Re: West Sewage Treatment Plant (STP) Improvements
Change Order No. 4
City of Crest Hill, Illinois (City)

CHANGE ORDER NO. 4

PROJECT: West Sewage Treatment Plant (STP) Improvements
OWNER: City of Crest Hill, Illinois
CONTRACT: 1-2022
CONTRACTOR: Vissering Construction Company

009-03 Drawing 77-ASME1.01 (Sheet 207)

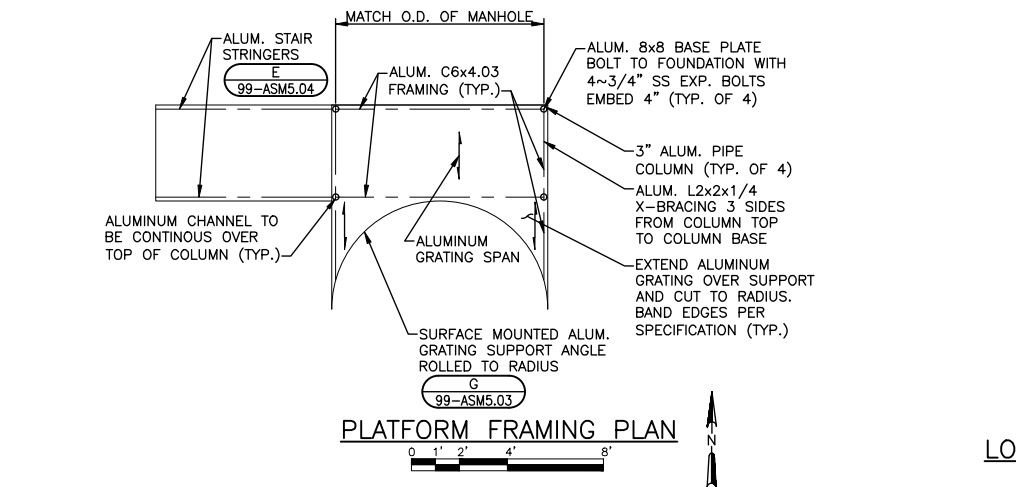
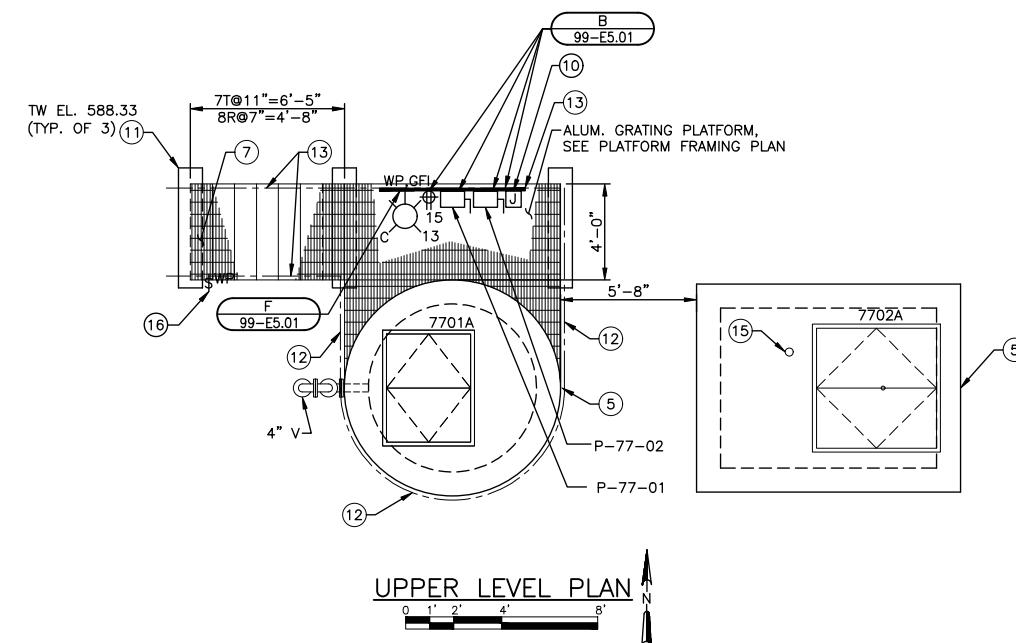
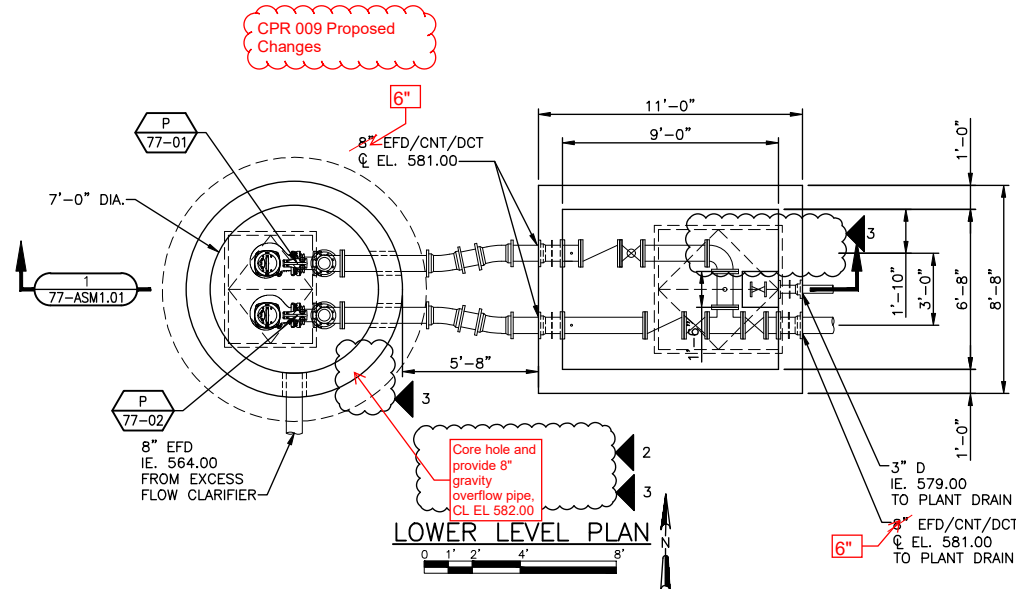
Refer to the attached updated drawing showing revisions to the force main size exiting Structure 77 to decrease the force main size to 6" diameter.

Refer to the attached updated drawing showing revisions to add an 8" diameter high water overflow from the Structure 77 wet well and fittings in the yard to attach to the plant drain.

Refer to the attached updated drawing showing revisions.

**SHEET
61
A10-E1.01**

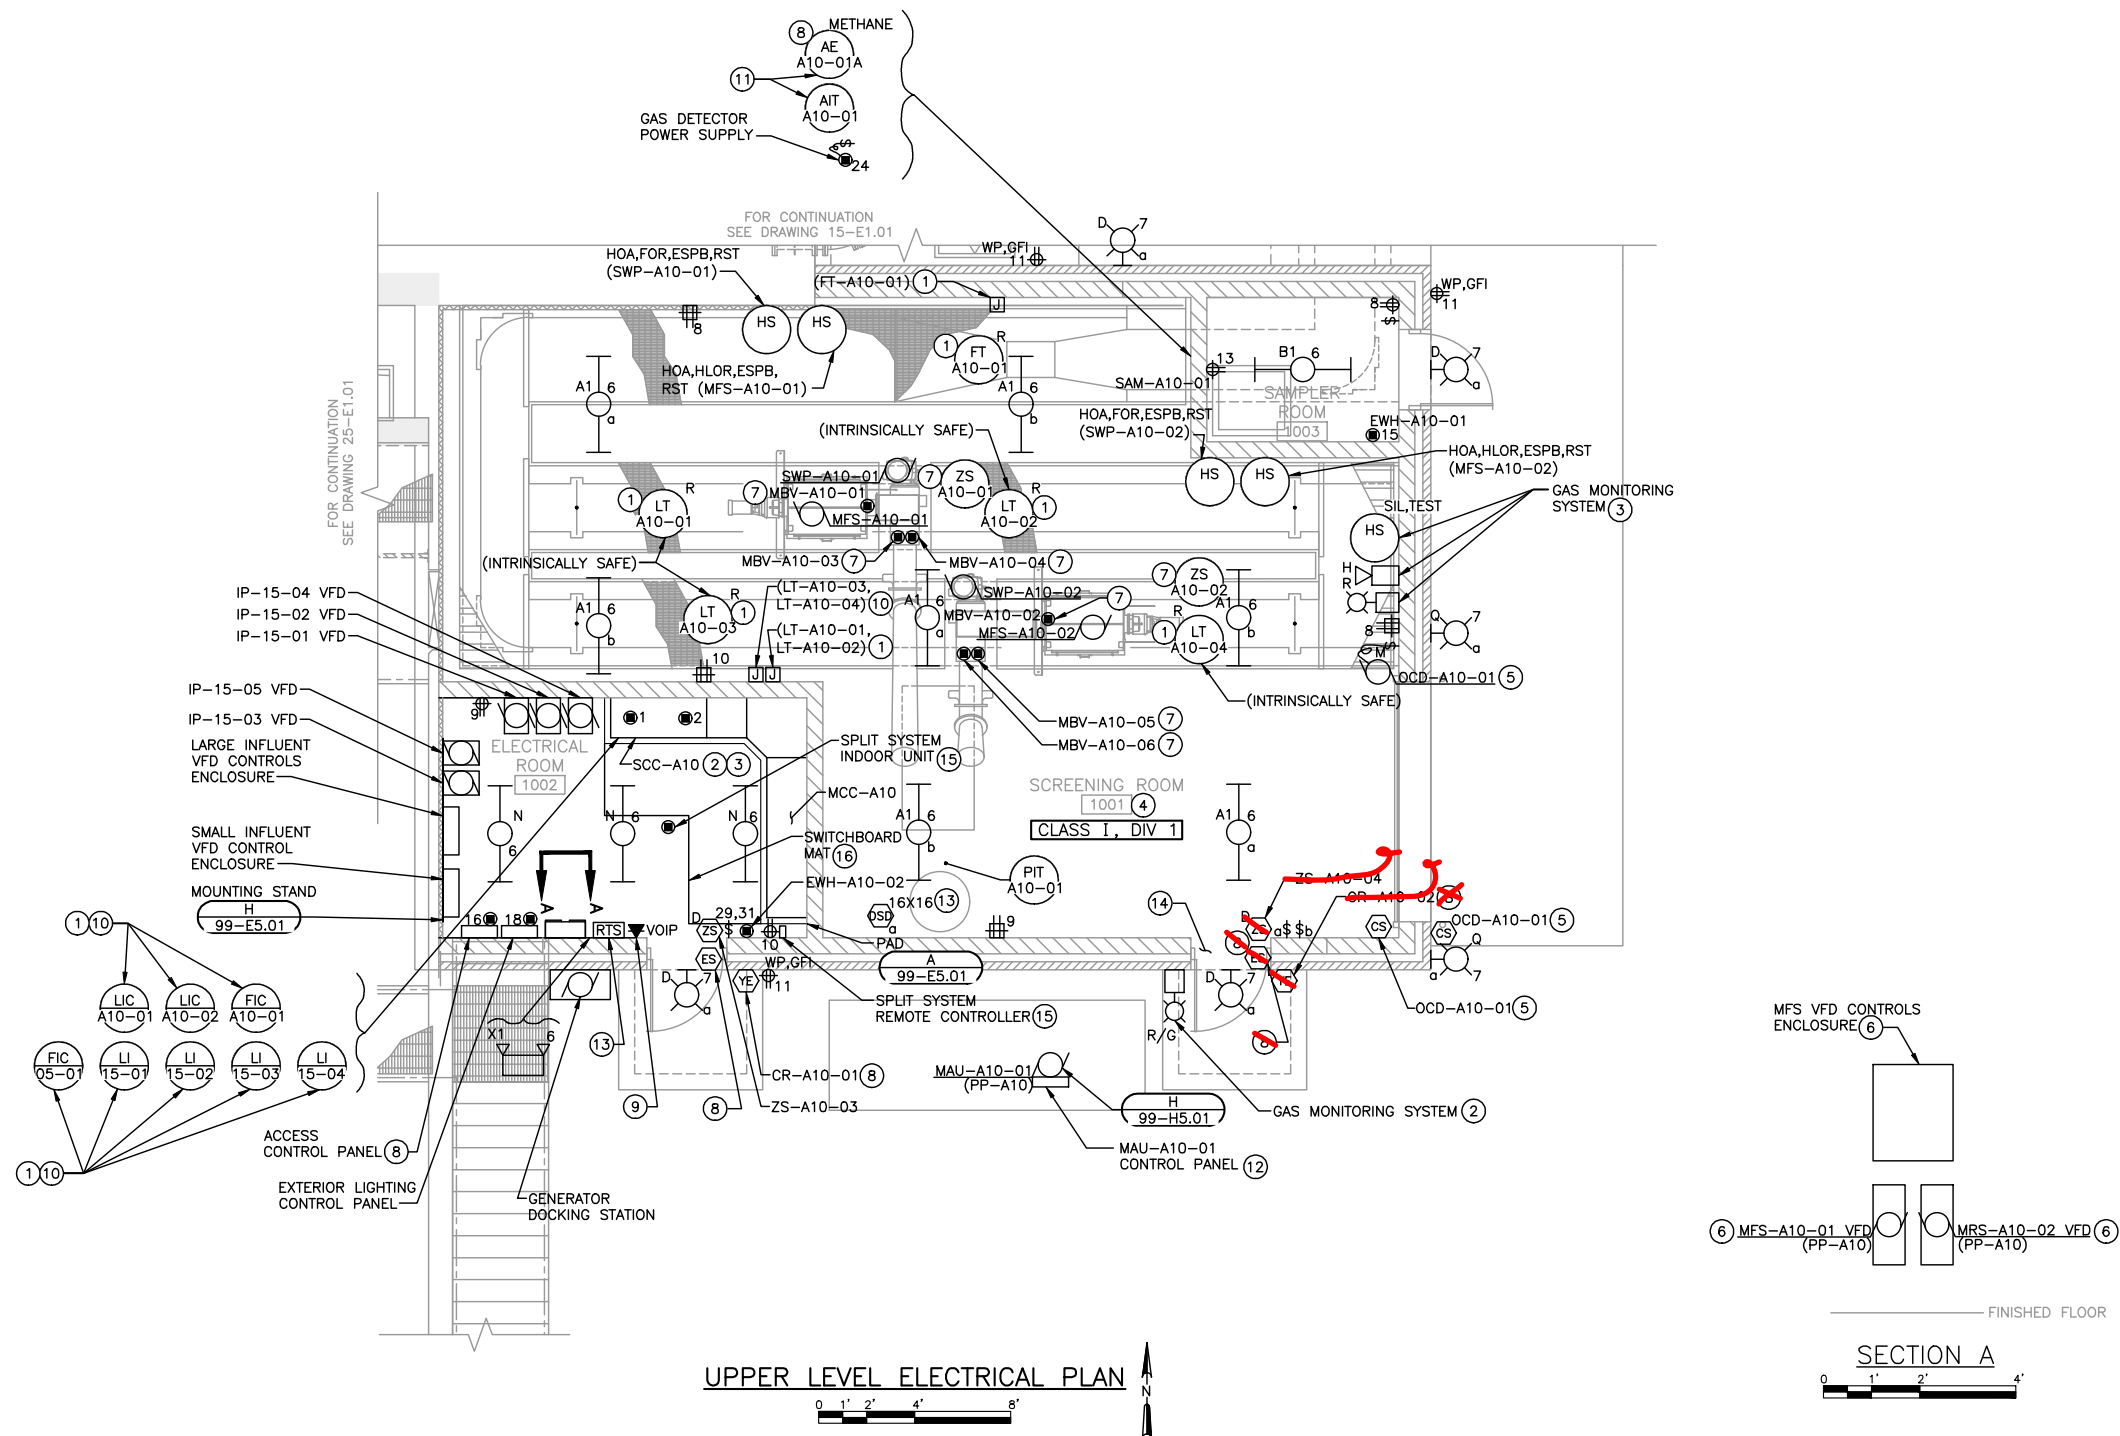
011-01 Drawing A10-E1.01 (Sheet 61)

Refer to the attached updated drawing showing revisions to the access control system. Changes include deletion of the system for the Screen Room 1001 at Door 1001B.

SHEET
86
B20-E1.01

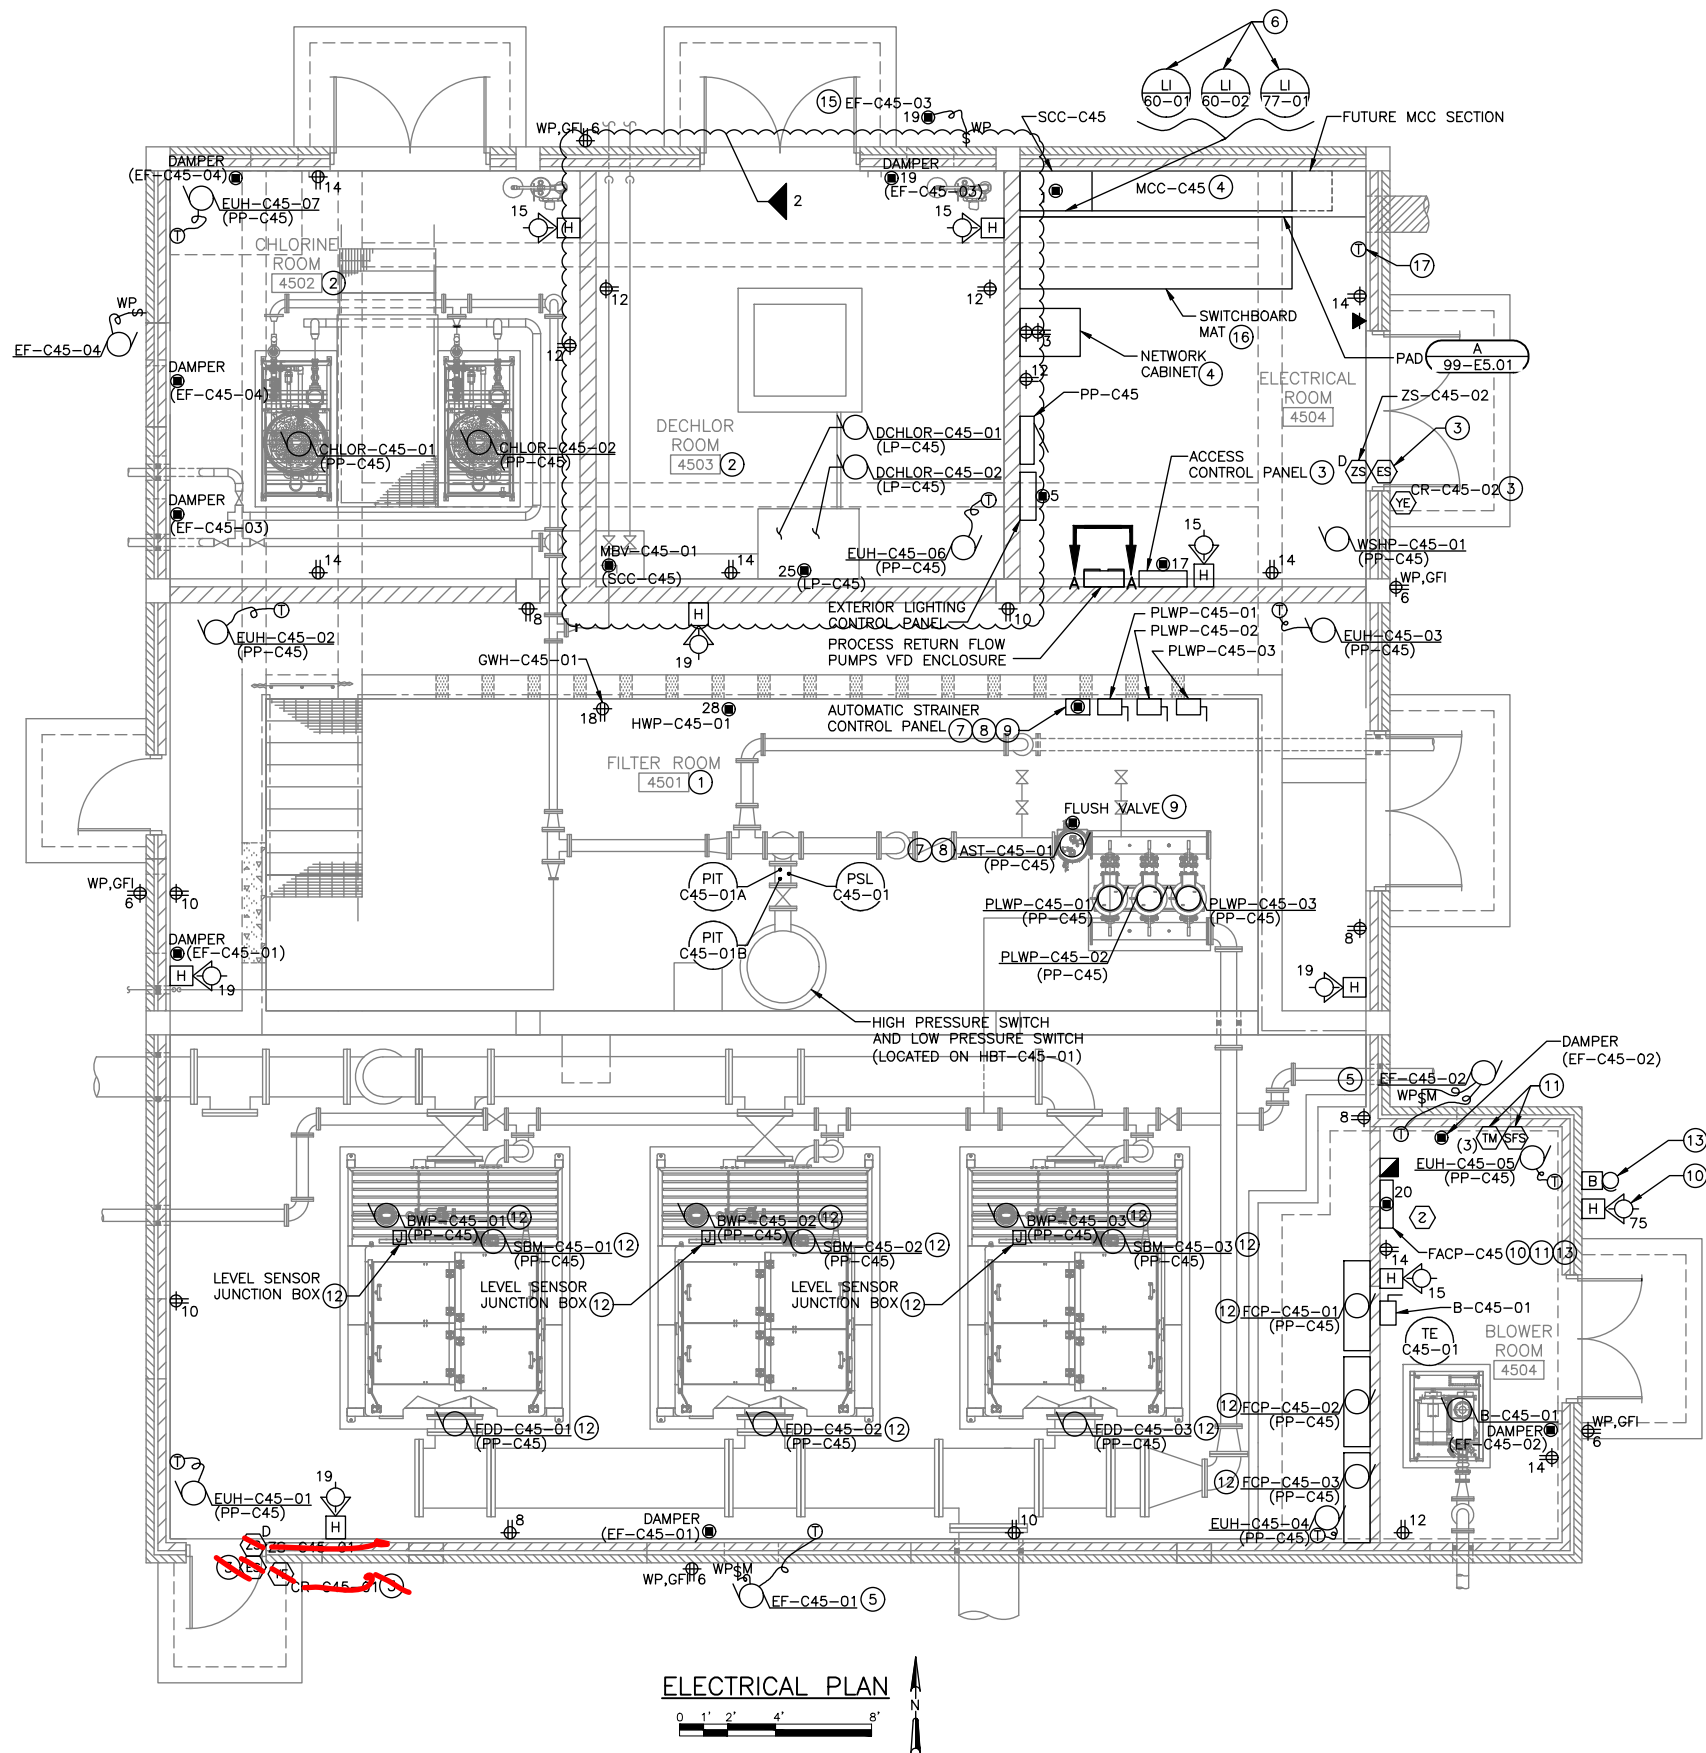
011-02 Drawing B20-E1.01 (Sheet 86)

Refer to the attached updated drawing showing revisions to the access control system. Changes include deletion of the system for the Dumpster Room 2003 at Door 2003C and addition of the system for the Electrical Room 2002 at Door 2002A.
